ADDENDUM '02'

Project Name Collingwood Green Phase 3
Toledo, Ohio

Addendum Date: February 13, 2017

Project: LMHA Collingwood Green, Phase III
 Toledo, Ohio
 Document: Addendum 02
 Reference Dwg: A201A
 Date: 02/10/17

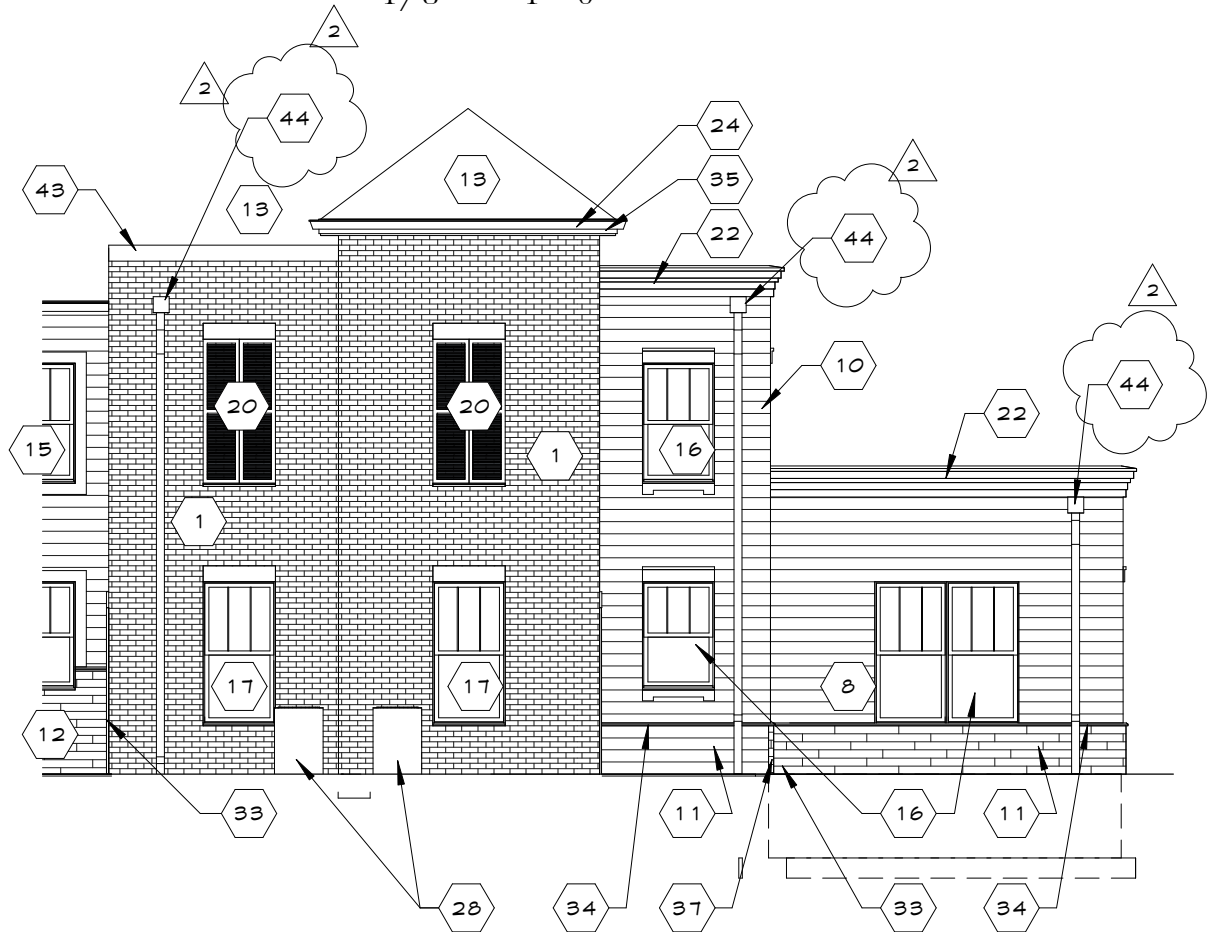
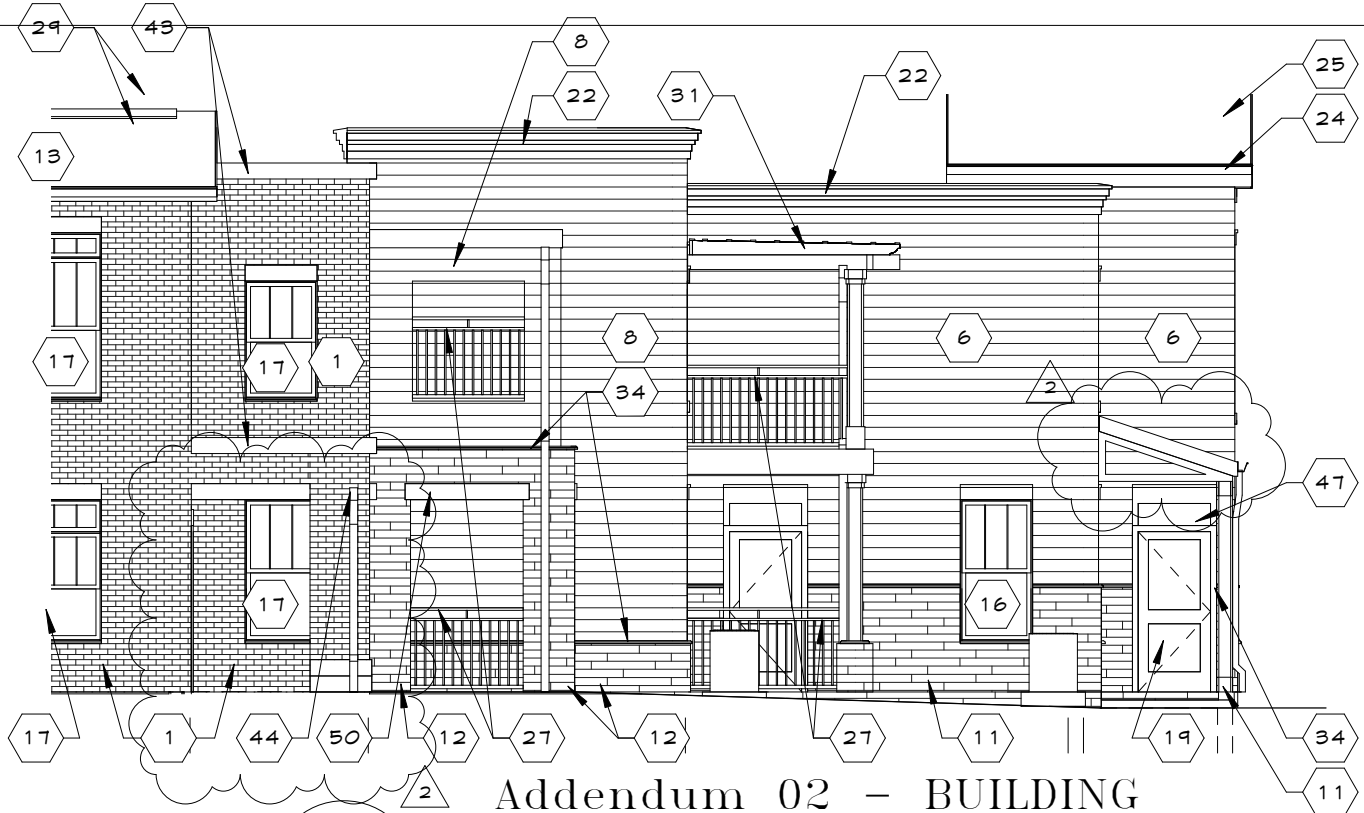
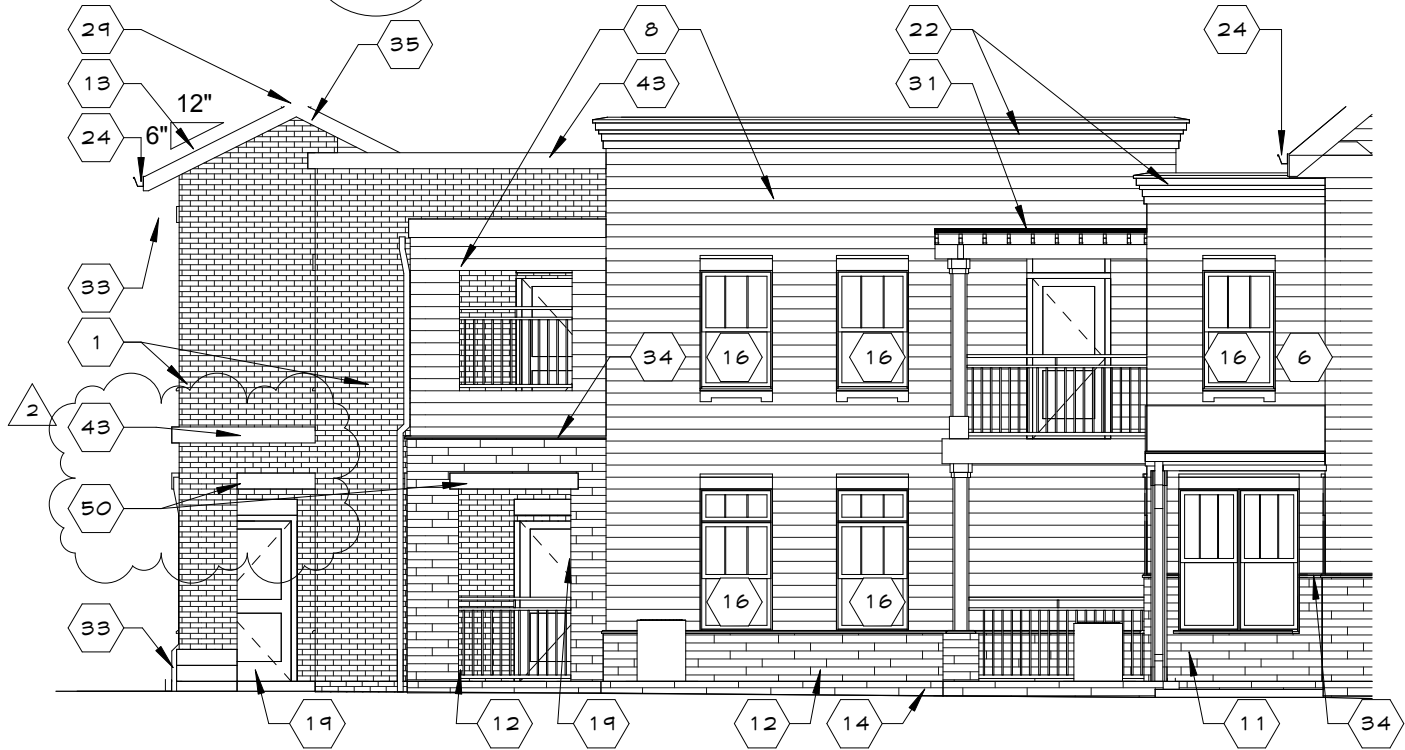
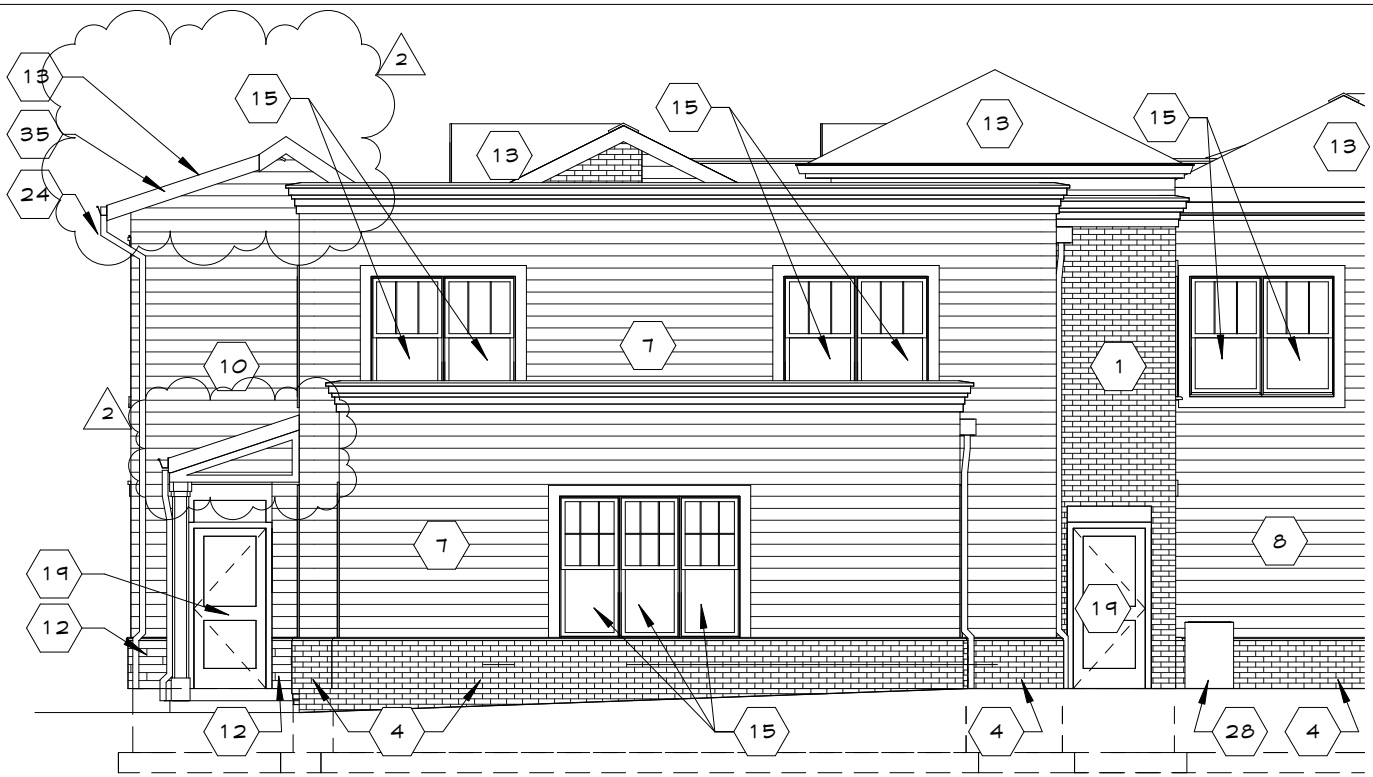
12. Sheet A201A
 - a. Add siding on sides of porch roof, add coded notes for siding above roof and scupper locations, and update grade on East Elevation.

- b. Add siding on sides of porch roof, add coded notes for limestone cornice and limestone head trim on West Elevation.
 - c. Add coded notes for cornice locations and limestone head trim on South Elevation

- d. Add coded notes to scupper and cornice locations and siding above roof on North Elevation
 - e. Add coded note 50 – Limestone Head Trim. See attached sketches

Project: LMHA Collingwood Green, Phase III
Toledo, Ohio
Document: Addendum 02
Reference Dwg: A201C
Date: 02/10/17

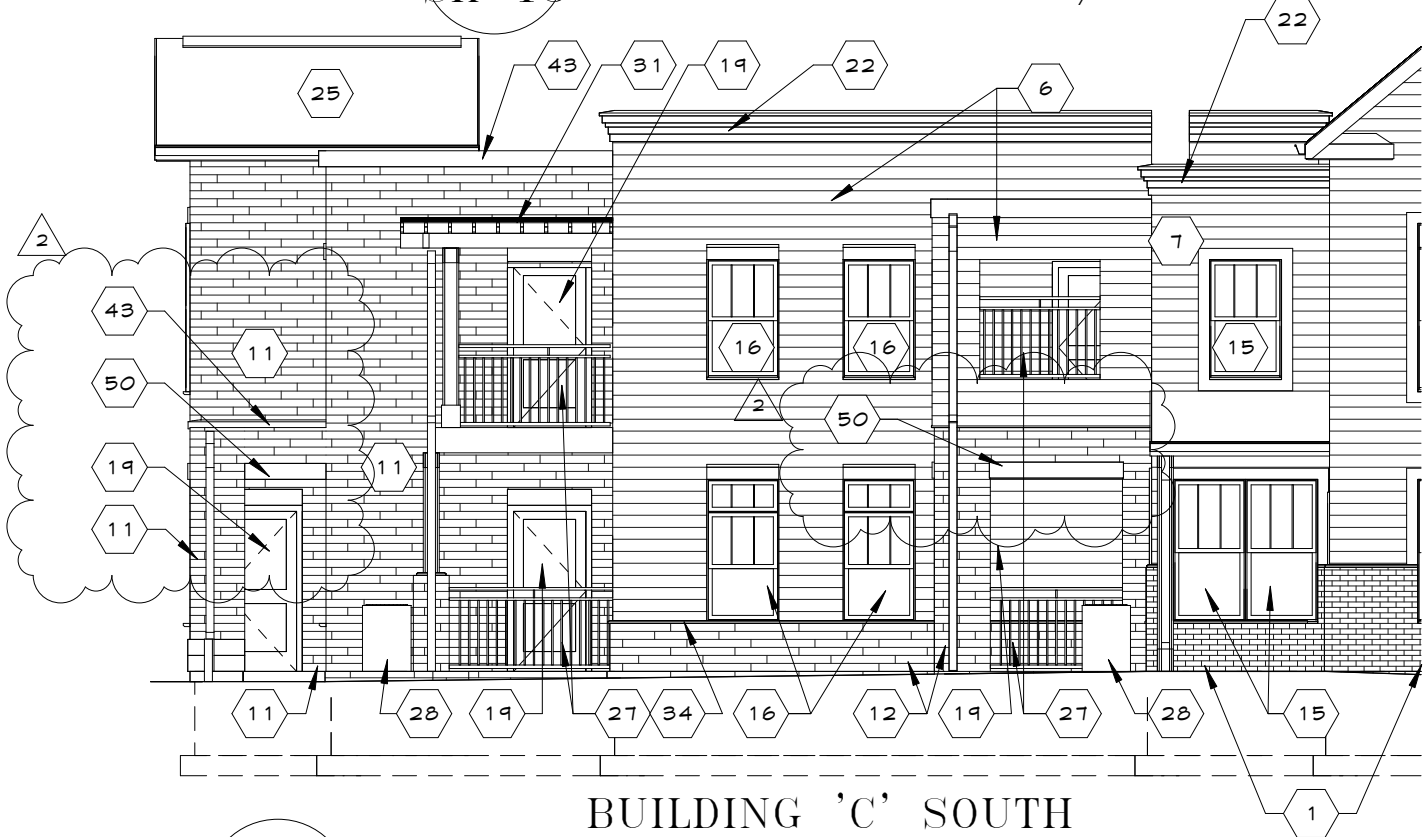
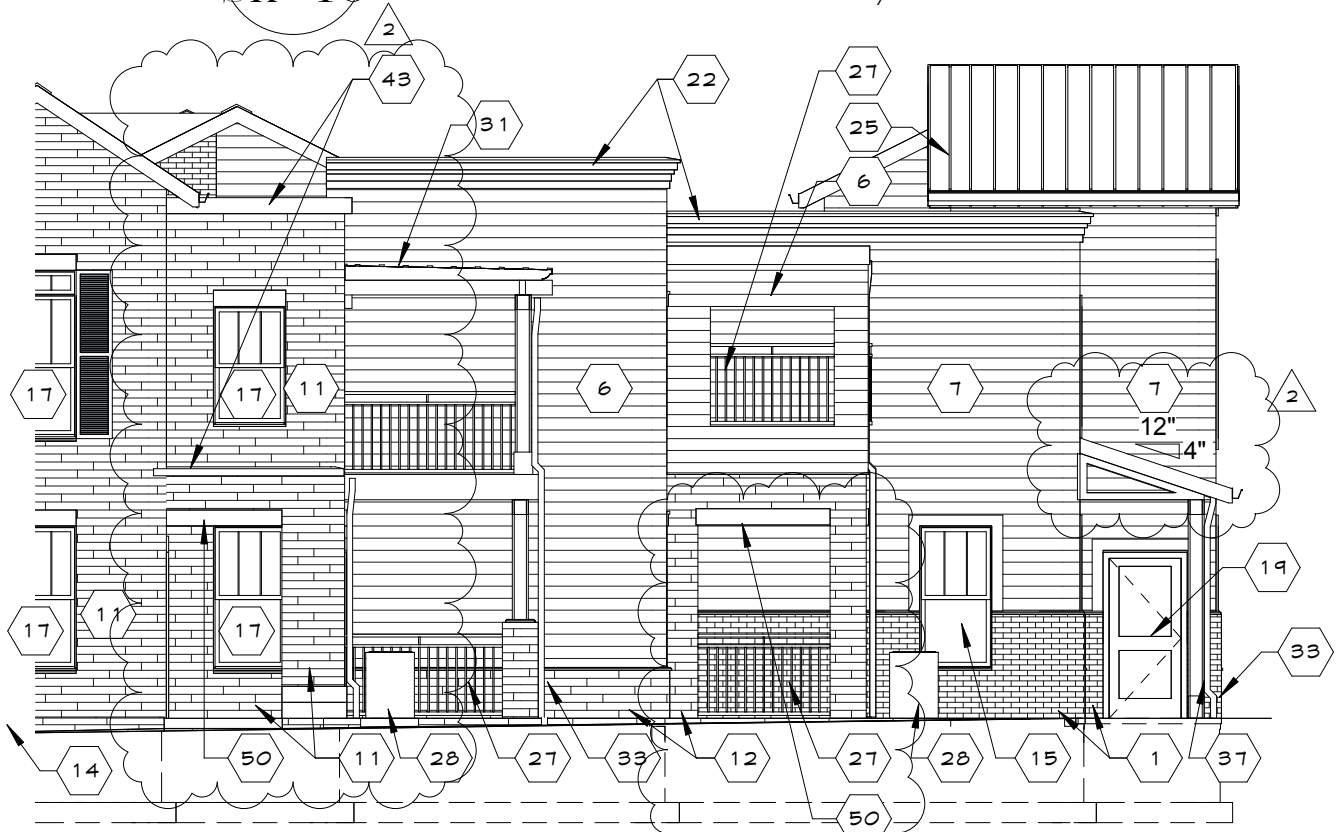
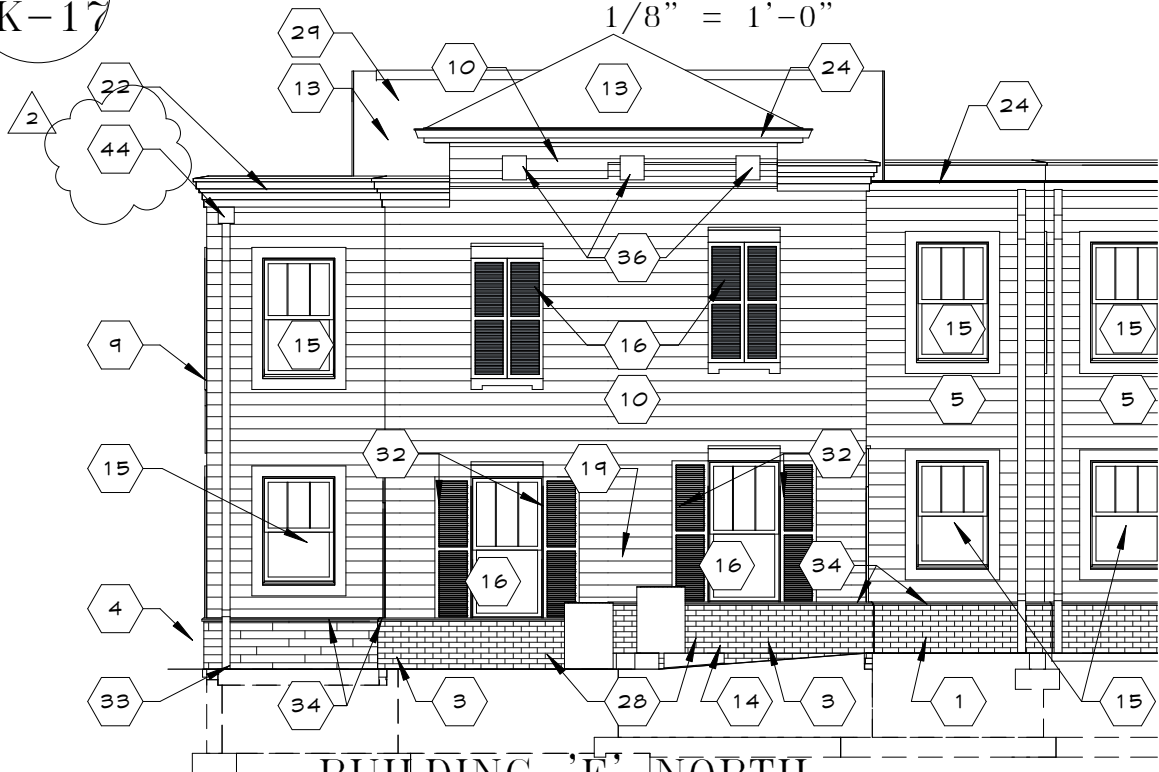
- e. Add coded note 50 – Limestone Head Trim. See attached sketches.
14. Sheet A201C
 - a. Add siding on sides of porch roof and coded notes for scupper locations on East Elevation.

- b. Add siding on sides of porch roof and limestone head and coded notes on West Elevation.
 - c. Add limestone head and coded notes on South Elevation

- d. Add coded notes to scupper locations on North Elevation
 - e. Add coded note 50 – Limestone Head Trim. See attached sketches
15. Sheet A201E
 - a. Revise roof slopes at shed roof areas on South Elevation

Project: LMHA Collingwood Green, Phase III
Toledo, Ohio
Document: Addendum 02
Reference Dwg: A201E
Date: 02/10/17

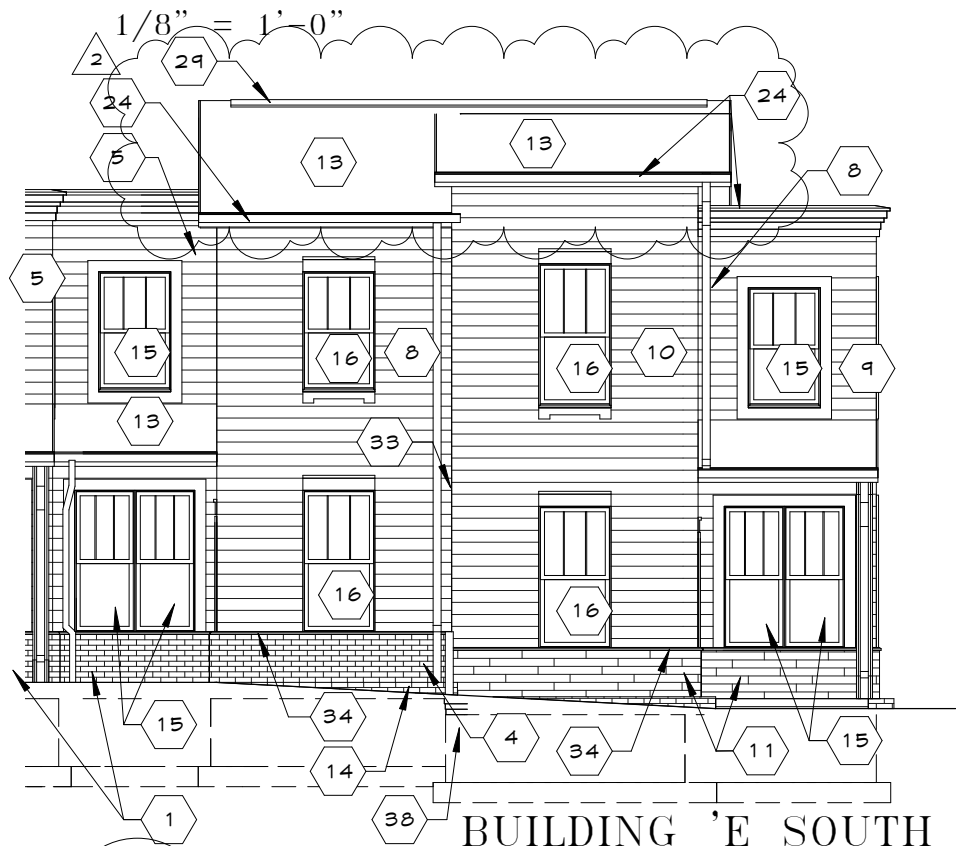
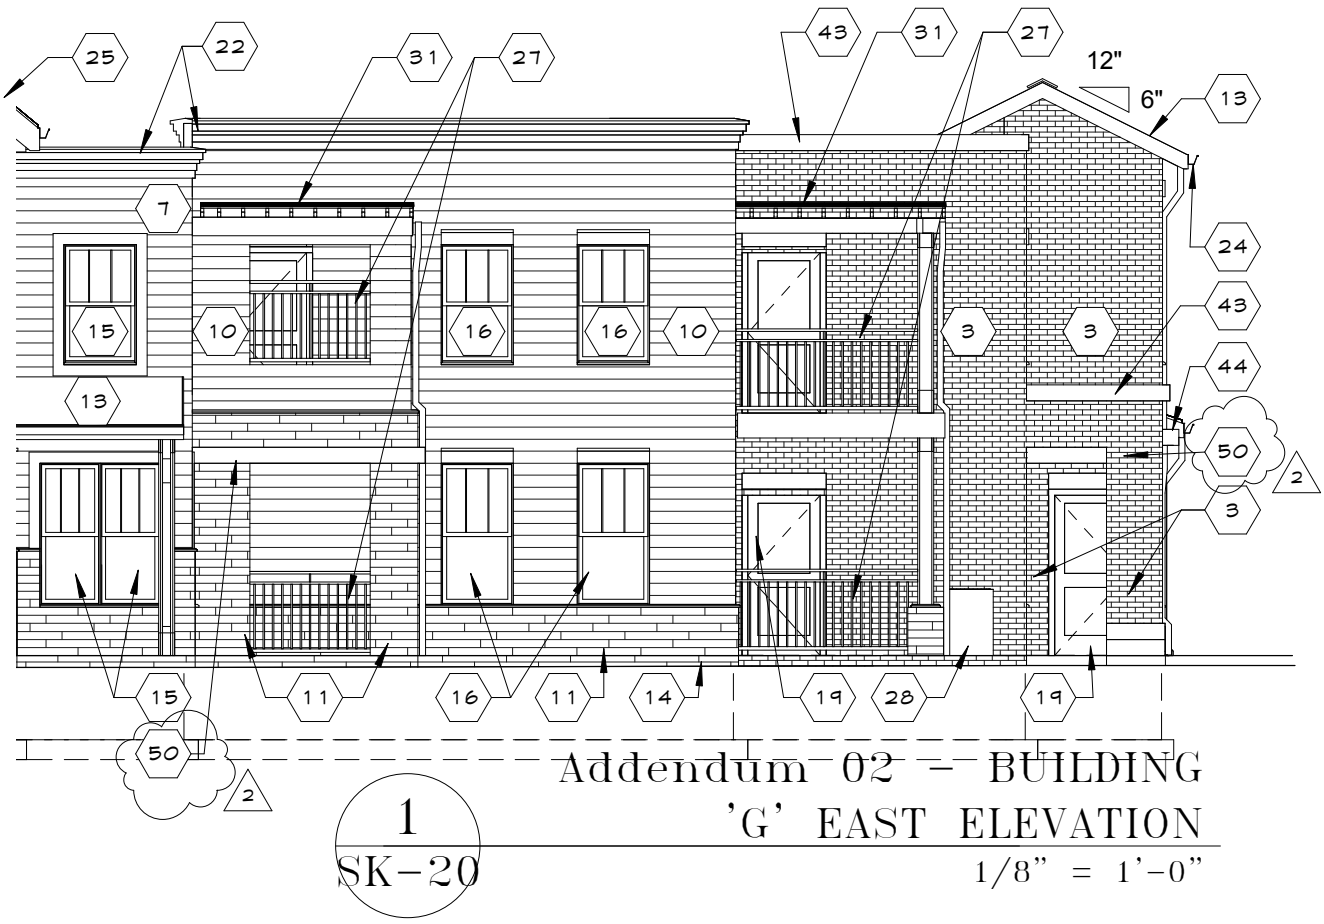
- b. Revise stone base on South Elevation
 - c. Revise windows on East and West Elevations
 - d. Add notes for siding above roof on West Elevation
 - e. Add coded note to scuppers and gutters on North Elevation. See attached sketches.

Addendum 02 - BUILDING
'G' EAST ELEVATION
1/8" = 1'-0"

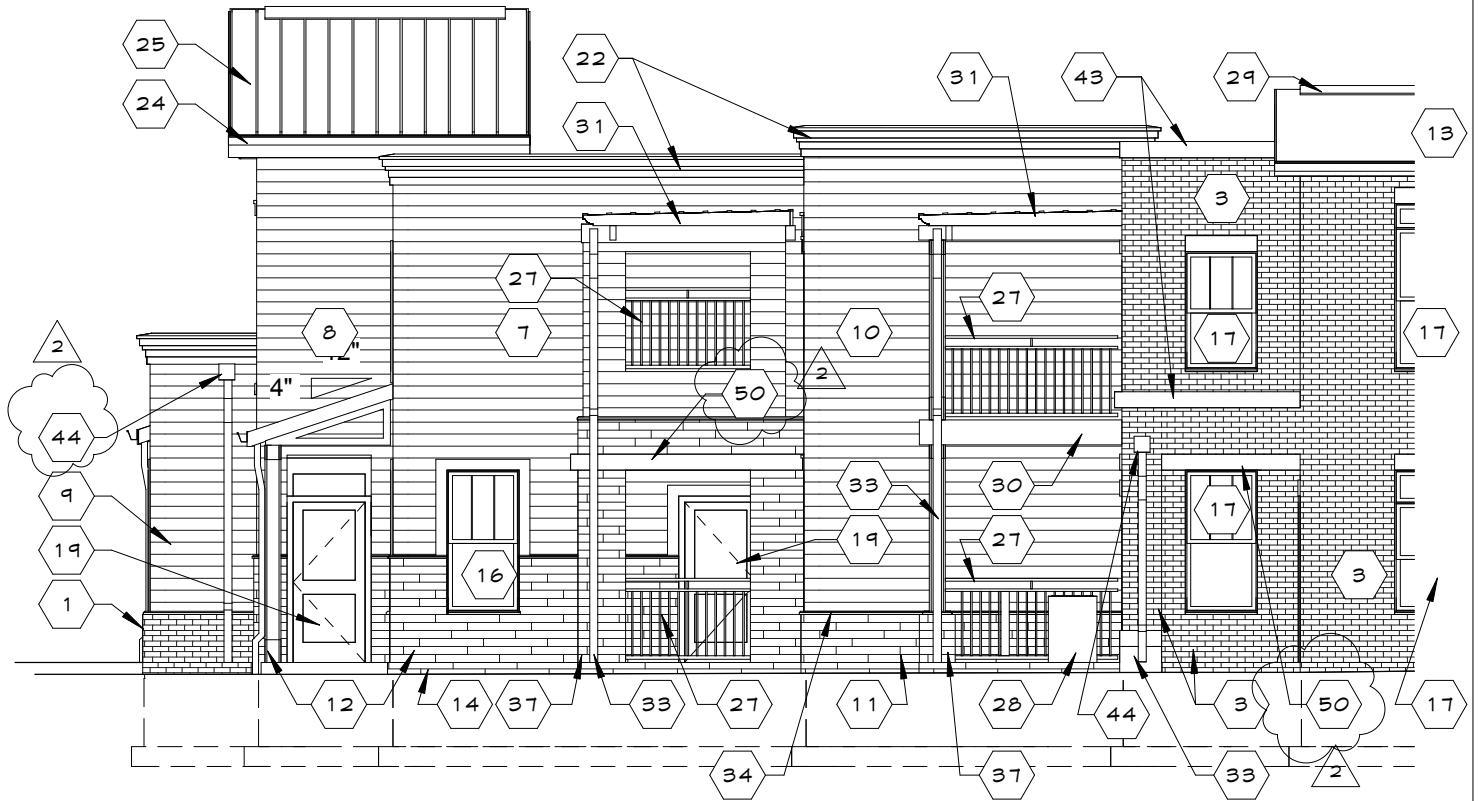
16. Sheet A201G
 - a. Add limestone head and coded notes on East and North Elevations
 - b. Add coded notes to scupper locations on West Elevation
 - c. Add coded note 50 – Limestone Head Trim. See attached sketches.
